Access Compliance Report

Public Rights-of-Way

(Curb Ramps)

Intersection ID: 10027835	Main Street: HAMILTON_CR	Cross Street: N/A	Location: S
ADA ID: 905388446BEE	Ramp Type: Perp	Initial Pass/Fail: Pass	Overall Compliance: No
Codes/Mitigation Info/Possible Solution		Field Measurements/Component Compliance

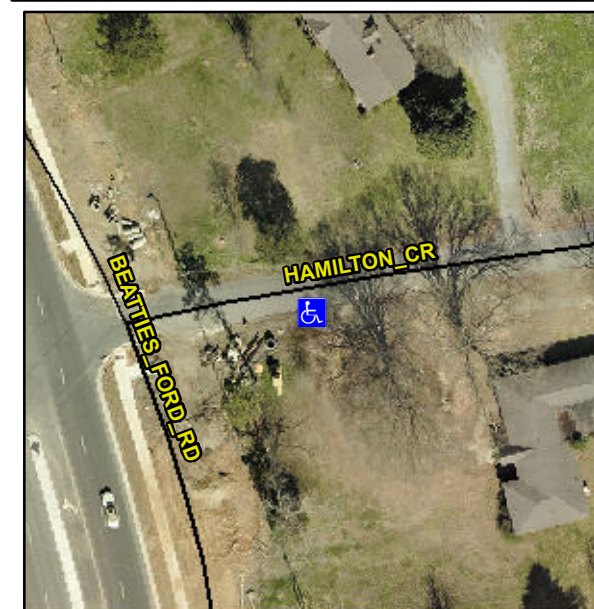
**Remove & Replace Entire Ramp.
Remove & Replace Gutter.**

R304.5.3, R305, R302.7.2

Compliance	Description	Data	Compliance	Description	Data
N/A	Ramp Length (in)	61.0	Yes	Ramp Slope (%)	5.8
Yes	Ramp Width (in)	77.5	No	Ramp XSlope (%)	4.9
N/A	Flare Type LT	None	N/A	Flare Type RT	N/A
N/A	Flare Slope LT (%)	N/A	N/A	Flare Slope RT (%)	N/A
N/A	Flare Traversable LT?	N/A	N/A	Flare Traversable RT?	N/A
Yes	Landing Length (in)	60.0	No	DWS Provided?	No
Yes	Landing Width (in)	70.5	N/A	DWS Contrast?	No
Yes	Landing Slope (%)	0.7	N/A	DWS Length (in)	N/A
Yes	Landing X Slope (%)	3.0	N/A	DWS Full Width?	No
N/A	Landing Curb? (Y/N)	No	N/A	DWS Offset (in)	N/A
N/A	Shared Landing?	No			
Yes	Gutter Ponding?	No	Yes	Gutter Slope (%)	4.6
No	Gutter Lip Ht (in)	0.5	No	Gutter X Slope (%)	3.5
N/A	Painted X Walk1?	No	N/A	Painted X Walk2?	N/A
	X Walk 1 Direction	To N		X Walk 2 Direction	N/A
N/A	X Walk 1 Width (in)	N/A	N/A	X Walk 2 Width (in)	N/A
	X Walk 1 Slope (%)	1.5		X Walk 2 Slope (%)	N/A
	X Walk 1 X Slope (%)	3.0		X Walk 2 X Slope (%)	N/A
